Technical Bulletin

Product: Bambi MAX Bucket (BBX)

Subject: IVC Voltage Clamp Addition

Action: Mandatory

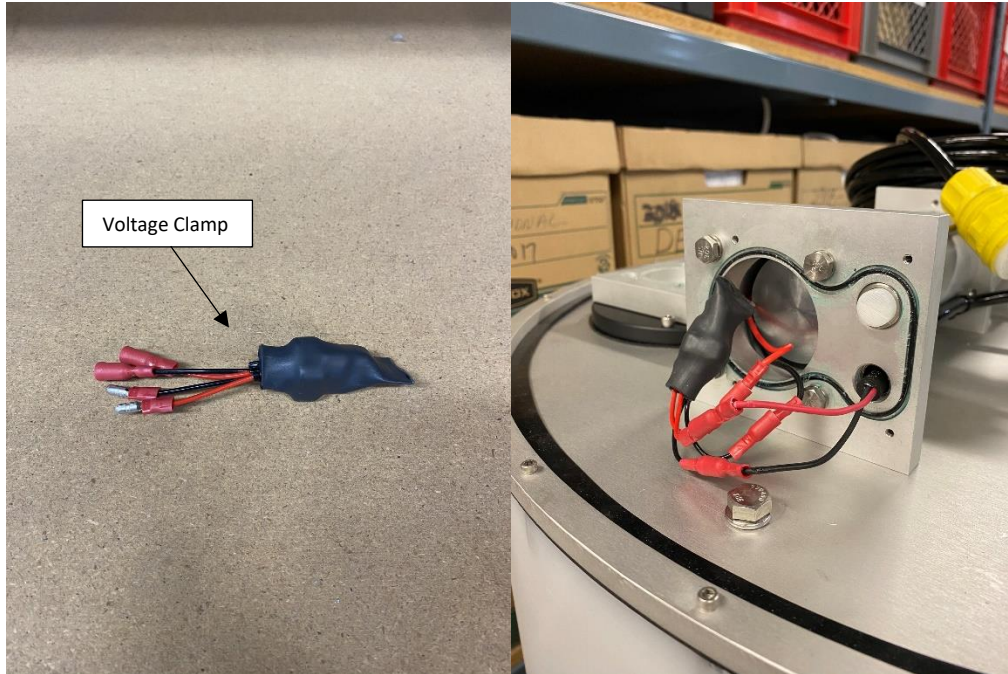
4. Install Voltage Clamp by connecting it to the motor wires, ensuring that the colour of the wires match.

5. Place Voltage Clamp into cavity. Ensure that the Voltage Clamp and bullet connectors do not protrude out of the cavity. This ensures that the cover can be replaced properly.
